2.12 Station Electrical Systems

The information in this section of the reference ABWR DCD, including all subsections, figures and tables, is incorporated by reference with the following departures.

STD DEP T1 2.12-1 (Tables 2.12.1, 2.12.12, 2.12.14 and 2.12.15)

STD DEP T1 2.12-2 (Figure 2.12.15)

Figure 2.12.15 Instrument and Control Power Supply

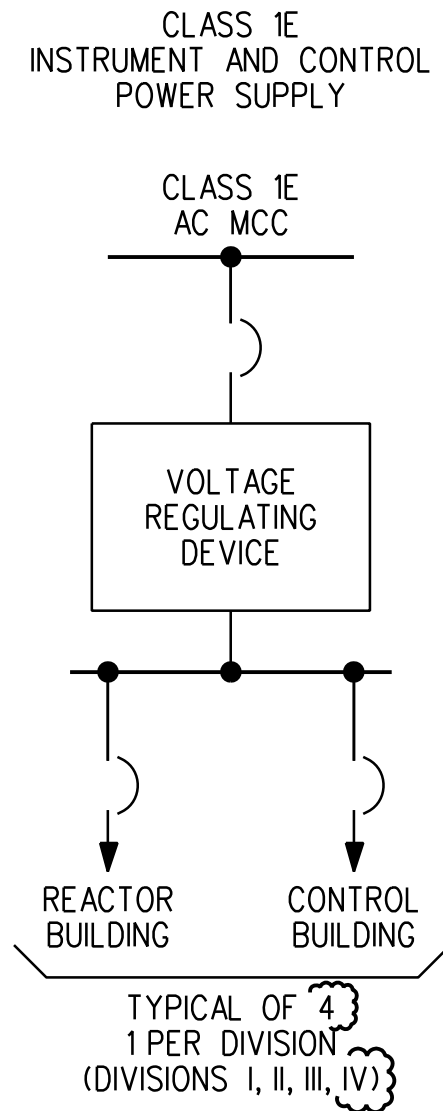
STD DEP T1 2.12-2

The Class 1E Instrument and Control Power Supply consists of ~~three~~ four divisions (Division I, II, ~~and~~ III, and IV) of interruptible power supplies with their respective distribution panels. Each Class 1E power supply provides interruptible, regulated AC power to Class 1E circuits which do not require continuity of power during a loss of preferred power (LOPP).
